Discussion of:

"Design Process of Deep Soil Mixed Walls for Excavation Support"

by Casandra J. Rutherford, Giovanna Biscontin, Demetrious Koutsoftas, and Jean-Louis Briaud

Thomas D. Richards, Jr, *Chief Engineer, Nicholson Construction Company, 12 McClane Street, Cuddy, PA 15031; email: TRichards@NicholsonConstruction.com*

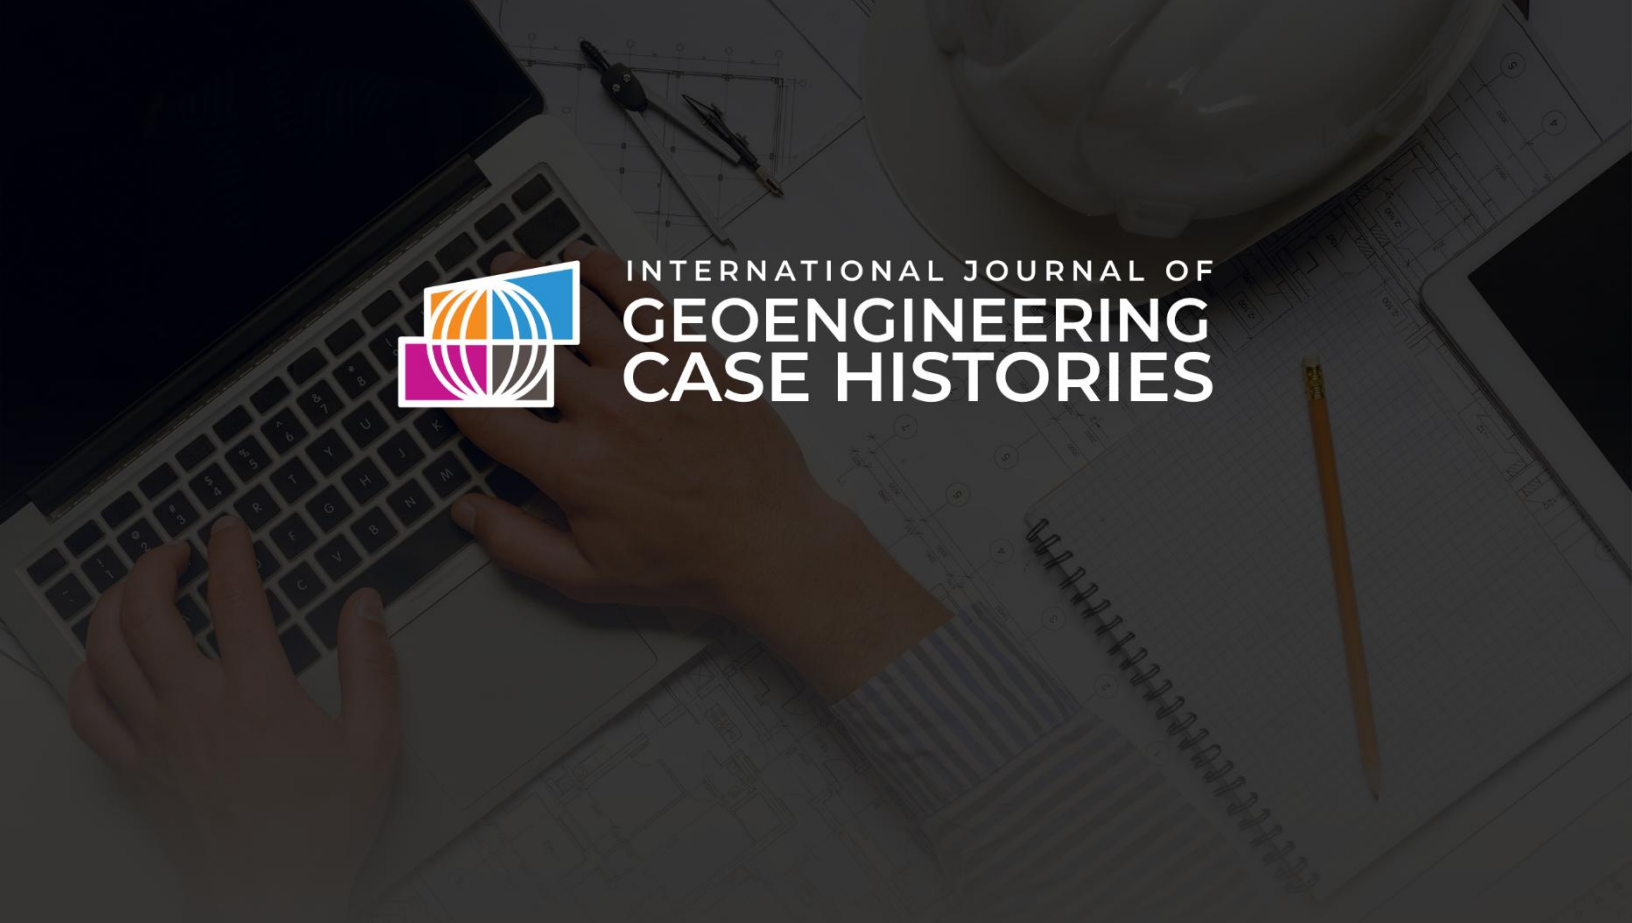
The discusser offers two comments on the shear resistance check (Figures 8 and 15).

2. Errors in Formula on Figure 15. The ACI method presented in the paper is a possible and probably conservative way of looking at shear resistance. However, the term "b_w" should be a unit vertical height and definitely not the clear distance between the beams. This clear distance between the beams has nothing to do with shear resistance, but does affect the applied shear. The use of b_w equal to the clear space is very unconservative. A better solution is to eliminate the b_w term as follows:

Note that the second 2 in the denominator has the units of psi$^{0.5}$. Also, note that the b_w term cancels out and is no longer in the equation.

Using λ of 0.75 is equal to factor of safety of 1/ λ = 1.33. This seems low but given the conservative concrete beam model may be appropriate.

Also, the term "d" should only extend to the excavated face of the beams.

$$V_{\max} = p \cdot L_2 \cdot b_w$$

Where:
p is the maximum earth pressure;
L2 the clear distance between flanges; and
bw is a unit depth.

$$V_c = \lambda \cdot 2 \cdot f_c^{0.5} \cdot b_w \cdot d$$

$$2 \cdot V_c > V_{\max} \quad \textit{from sum of forces}$$

$$2 \cdot (\lambda \cdot 2 \cdot f_c^{0.5} \cdot b_w \cdot d) > p \cdot L_2 \cdot b_w$$

$$\Rightarrow f_c^{0.5} > (p \cdot L_2 \cdot b_w) / (2 \cdot (\lambda \cdot 2 \cdot b_w \cdot d))$$

$$\Rightarrow f_c^{0.5} > (p \cdot L_2) / (2 \cdot (\lambda \cdot 2 \cdot d))$$

$$\Rightarrow f_c > [(p \cdot L_2) / (2 \cdot \lambda \cdot 2 \cdot d)]^2$$
